ADA IMPROVEMENTS/ELEVATOR

**WESTERN MIDDLE SCHOOL
1 WESTERN JR HIGHWAY
GREENWICH, CT 06830
BID #2569-26**

S/P+A PROJECT #23.097

DATE: March 19, 2026

Drawing Number:
E021

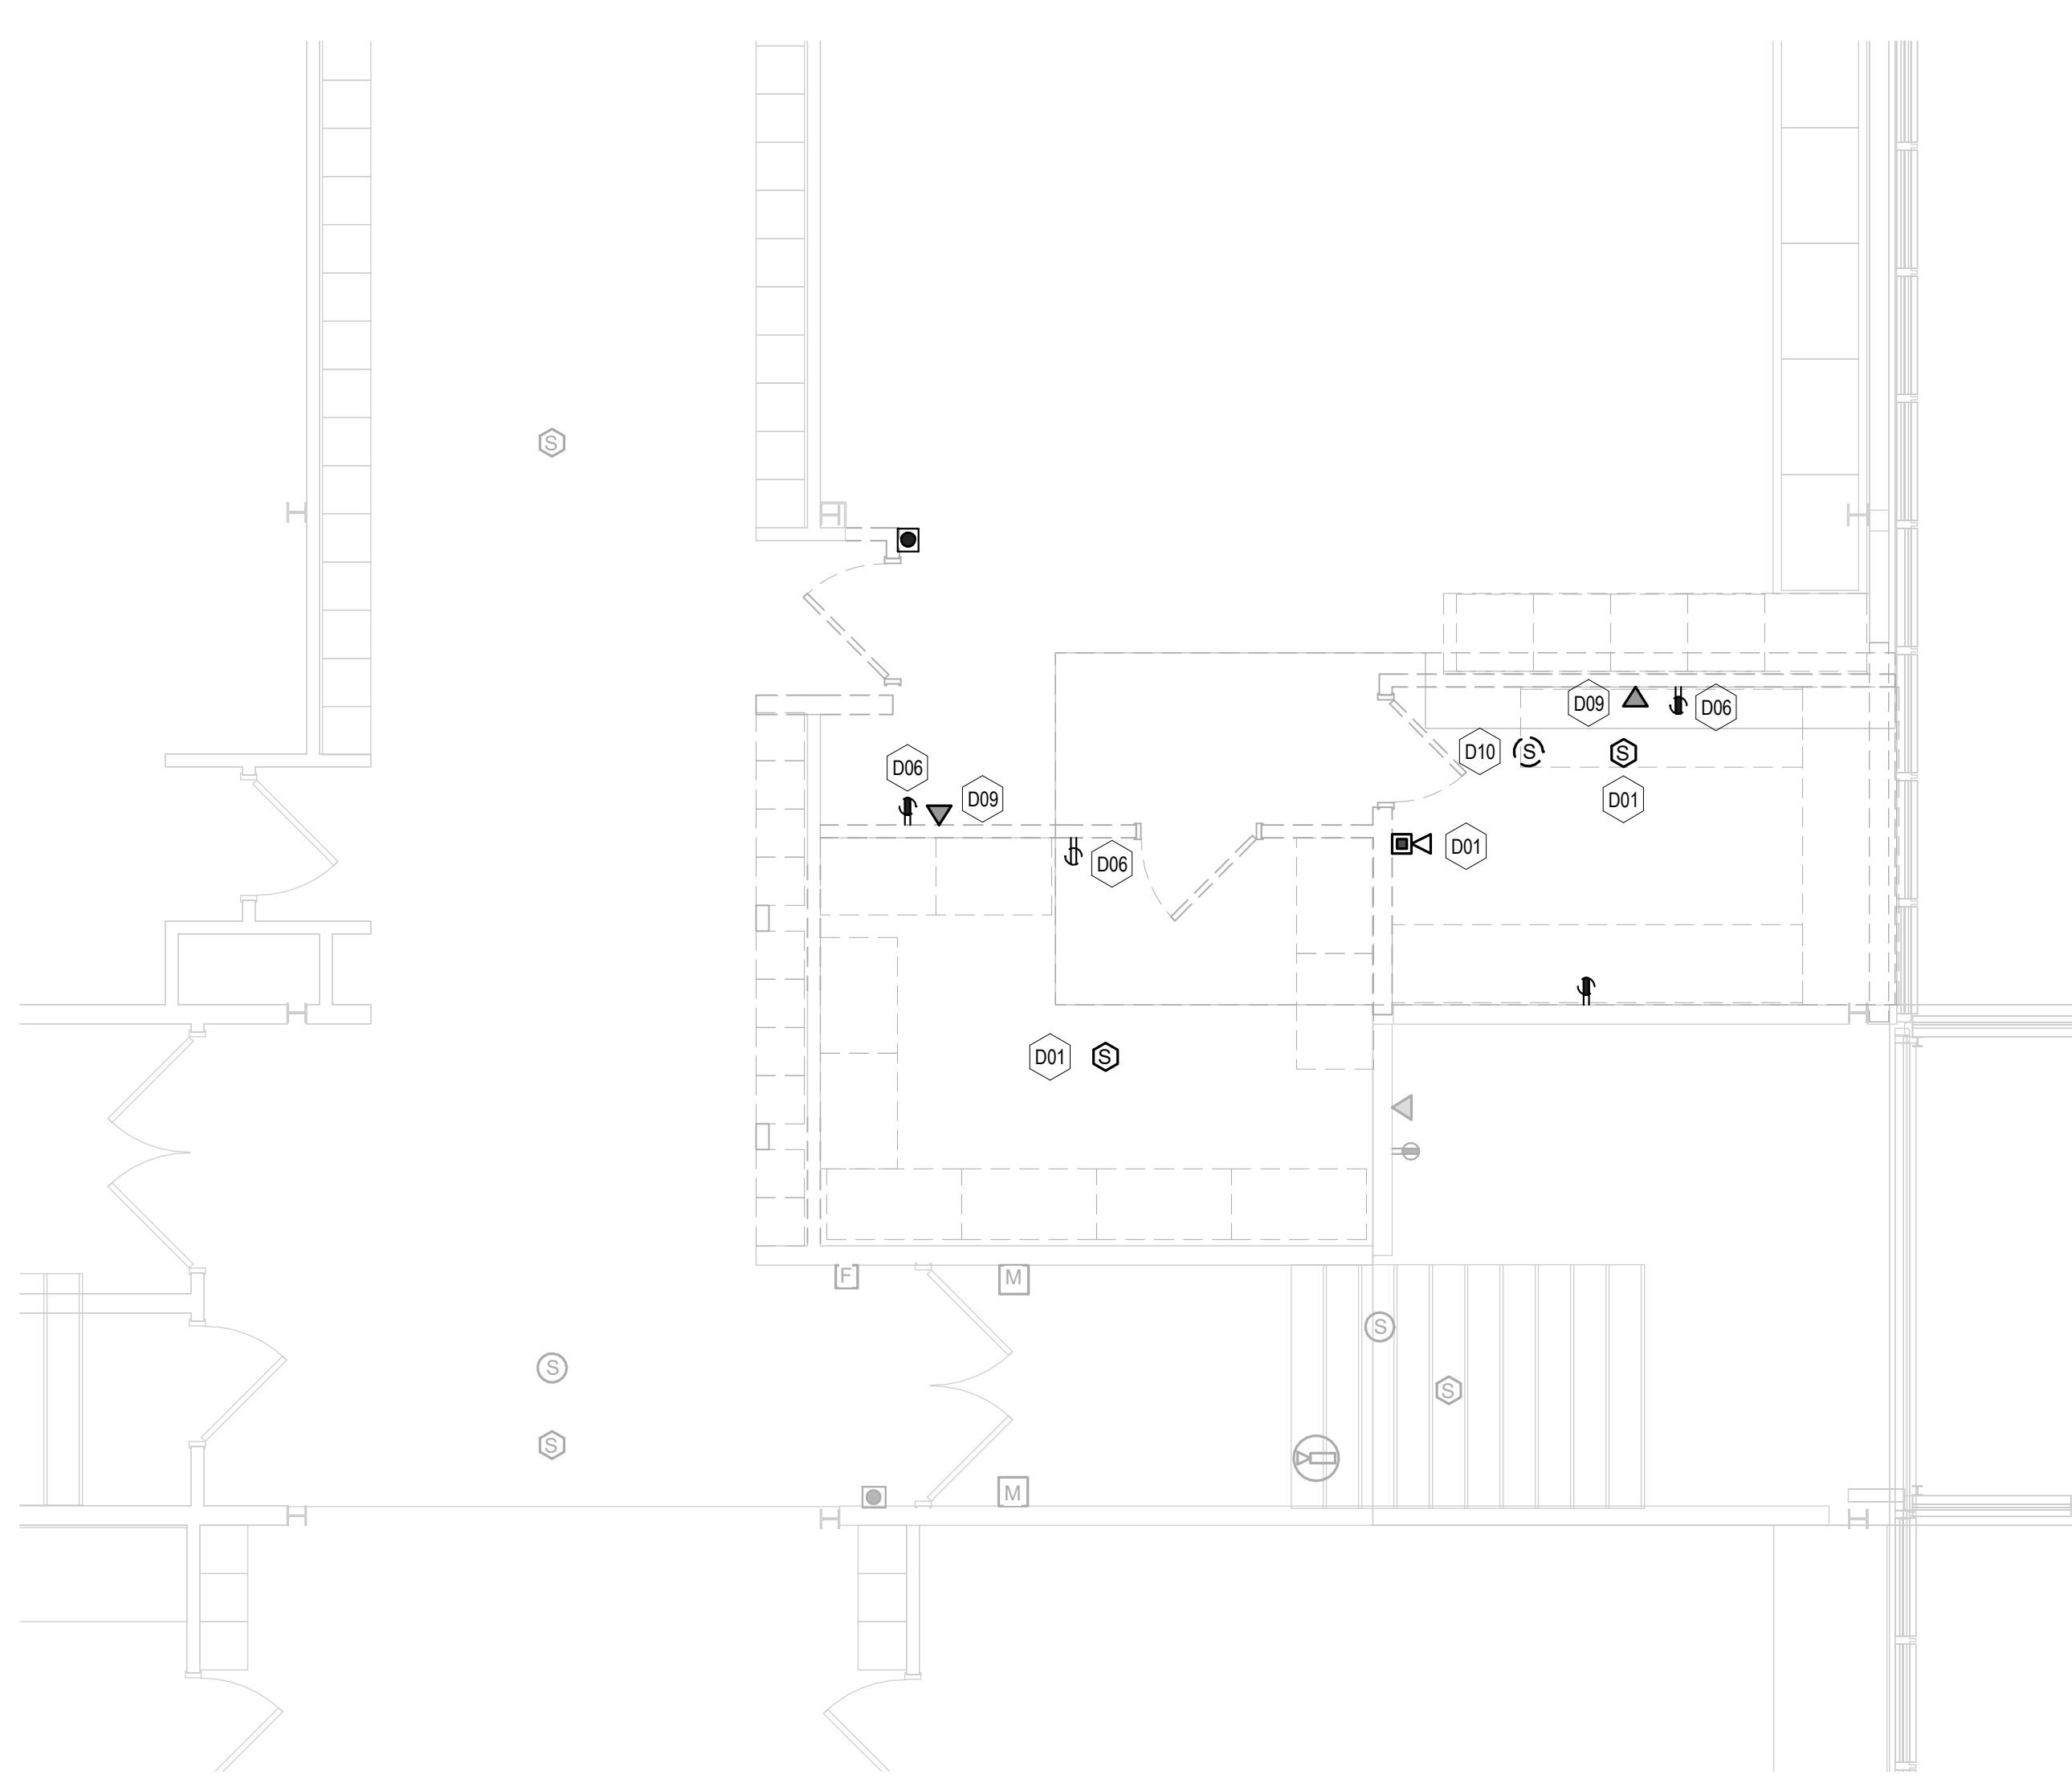
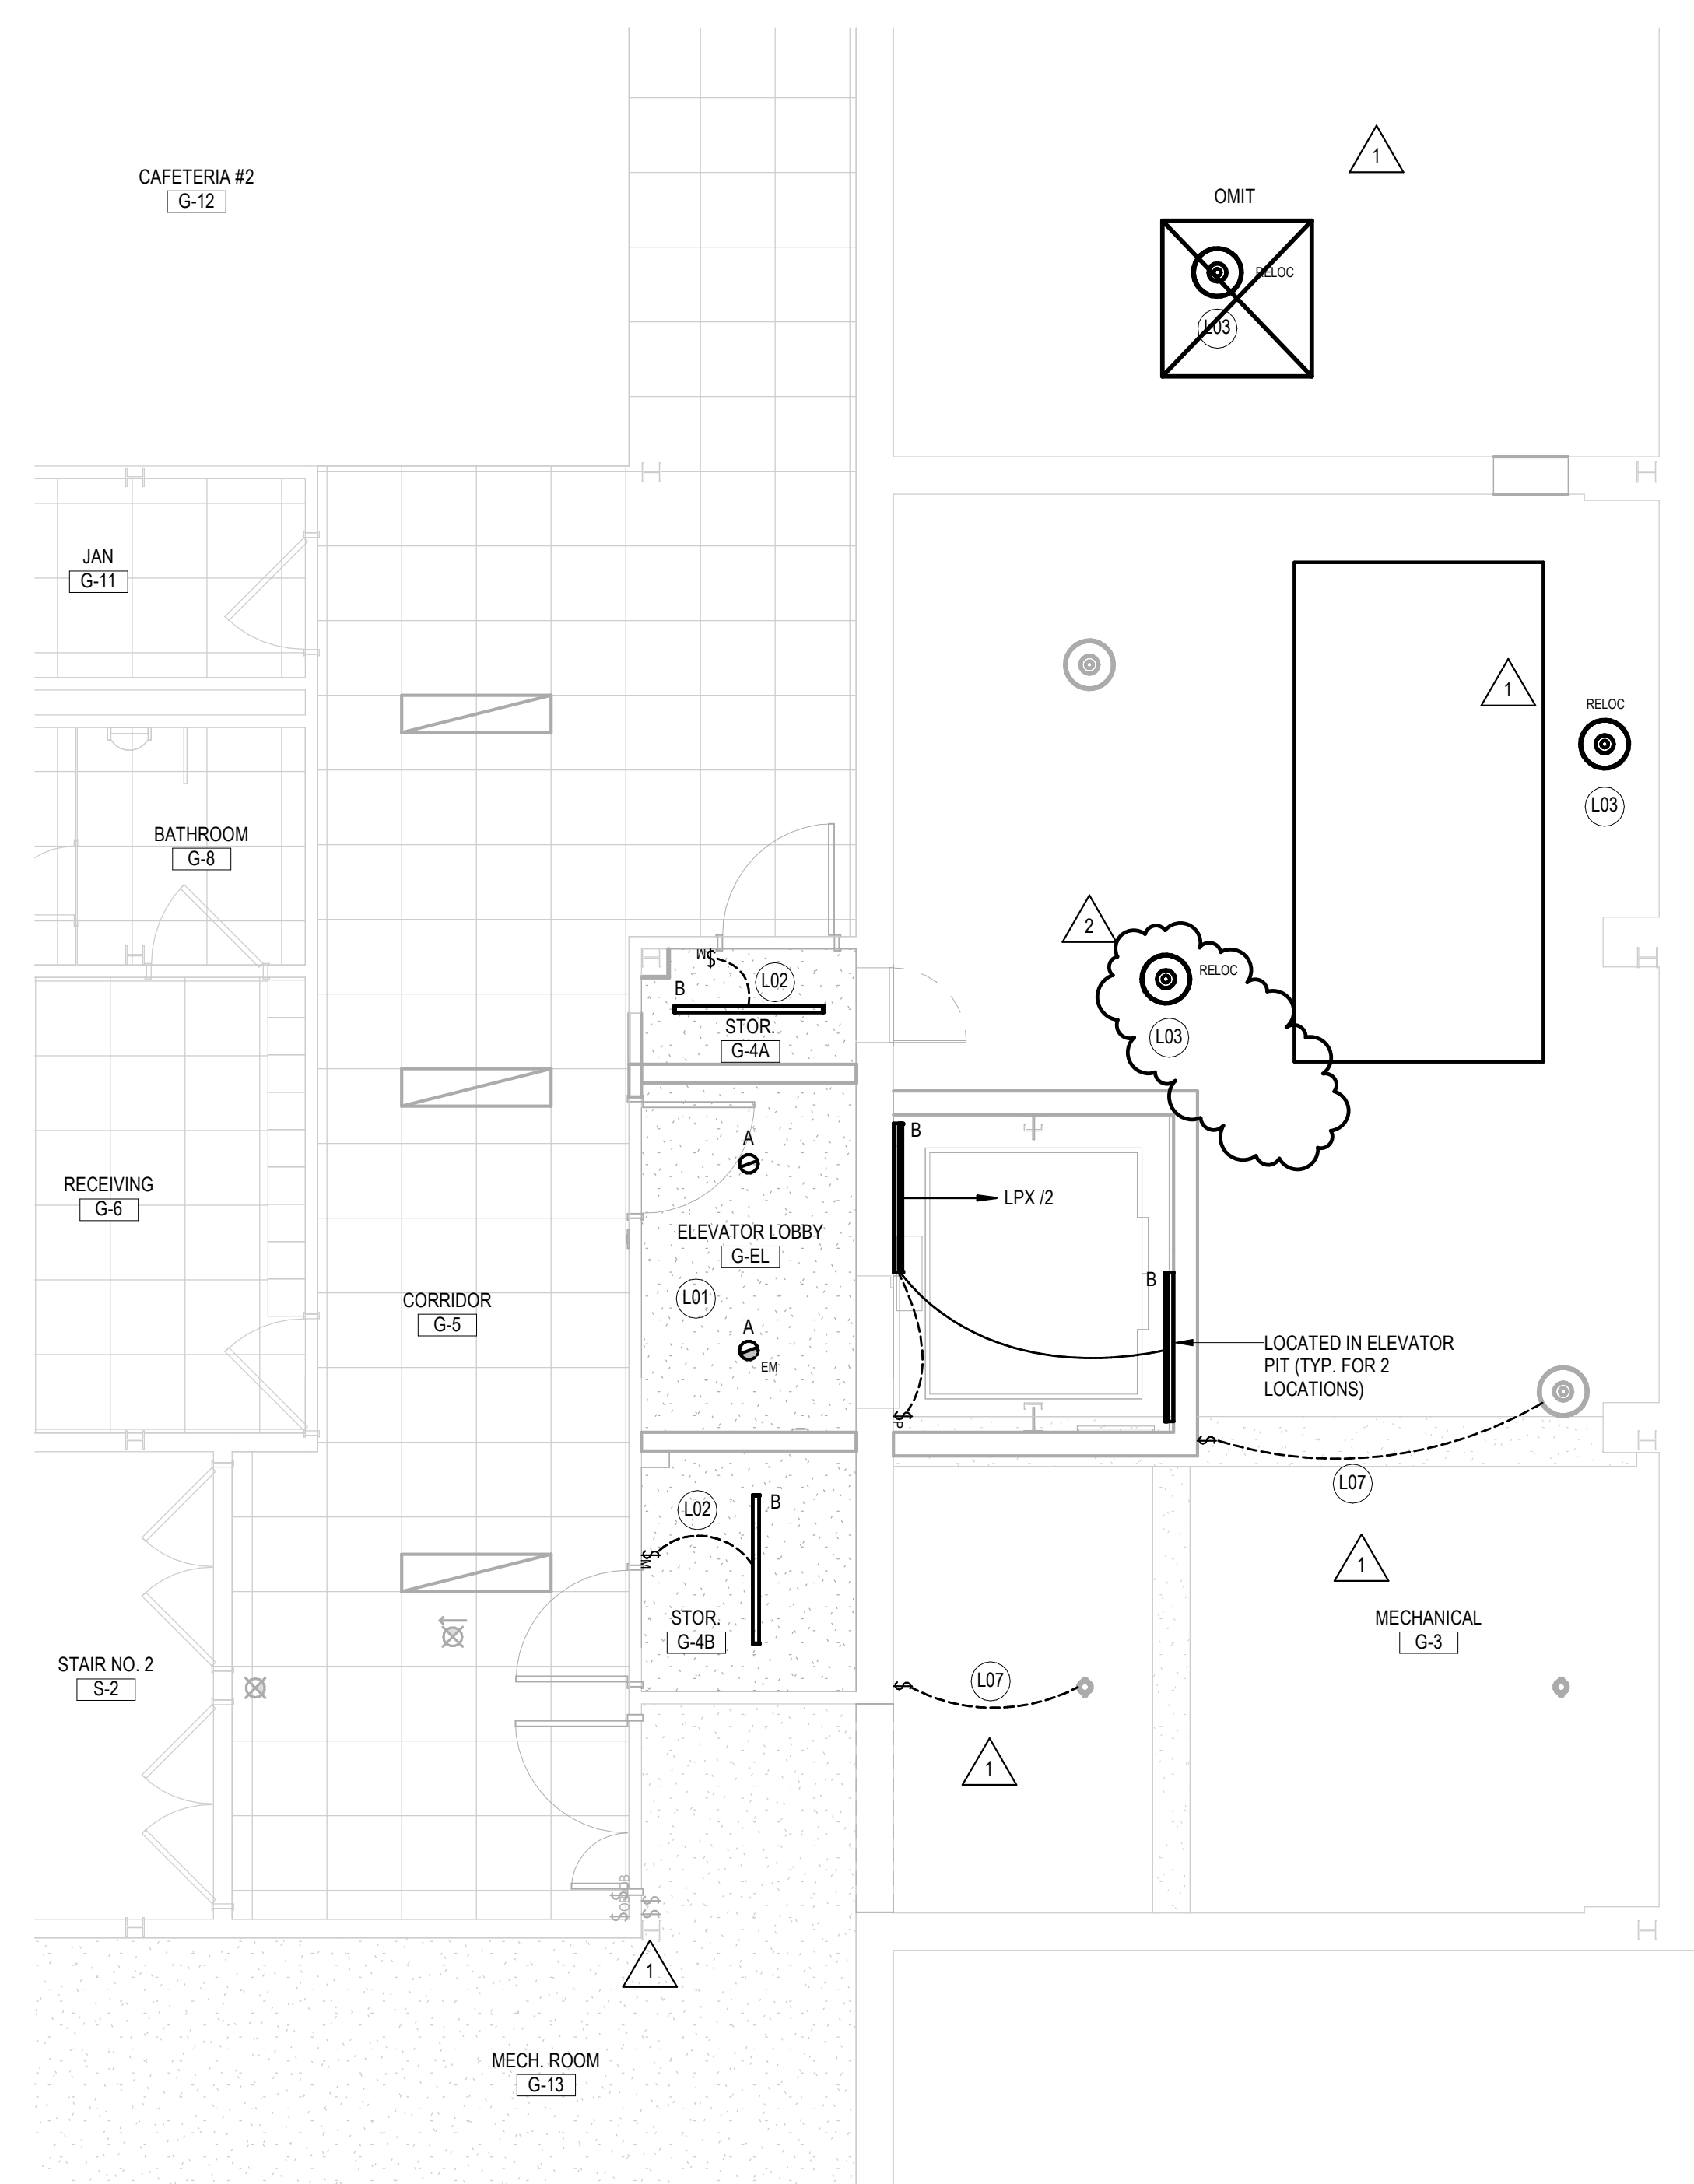
- E021 DEMOLITION FLOOR PLANS – POWER (*Per RFI #006*)
 - E111 LOWER & MAIN LEVEL FLOOR PLANS – LIGHTING (*Per Internal Review*)

Drawing Number:
P501

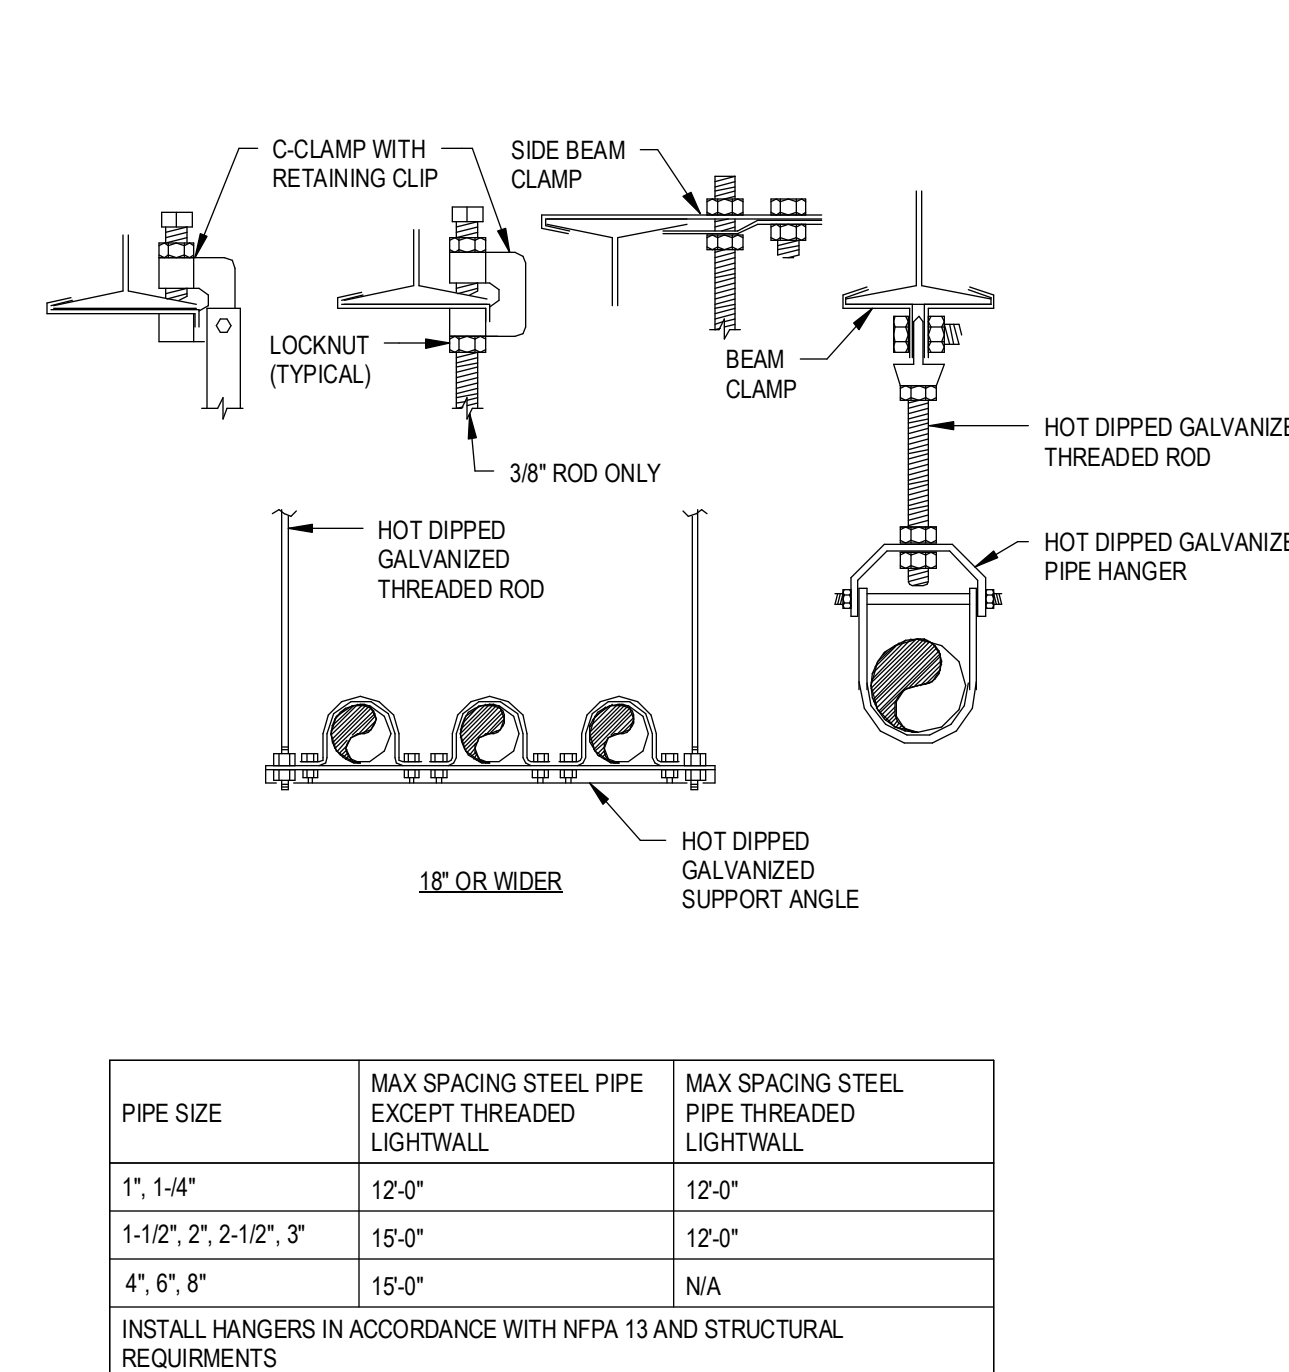
- DRAWING P501, PLUMBING SCHEDULES & DETAILS has been deleted in its entirety. A new DRAWING P501 has been added and is attached as part of this addendum.* (*Per RFI #008*)

008	Countertops - Details on A850 call for 1/2" quartz tops and backsplash, but in the spec section 123553.19, calls for Epoxy Resin top with integral sink. The plumbing fixture specs on drawing P501, S-1, calls for a specific manufactured sink.	03/17/26	Refer to RFI #002. Sink specified in Plumbing Fixture Schedule is an integral sink. Refer to Addendum #4 for revised Drawing P501.	5
009	A100 - Elevator shaft shown to go thru an existing concrete beam. S1.1 - shows beam to be an existing B2 16x20. There isn't a section cut through this area. What is happening at this beam?	03/17/26	The existing beam alignment has been adjusted to our understanding of the existing drawing. The intent is the elevator wall will be aligned with the existing beam. Field verification of the proposed layout will be required prior to any demo work to confirm existing conditions align as anticipated. Refer to Addendum #5 for revised Drawing S1.1.	5
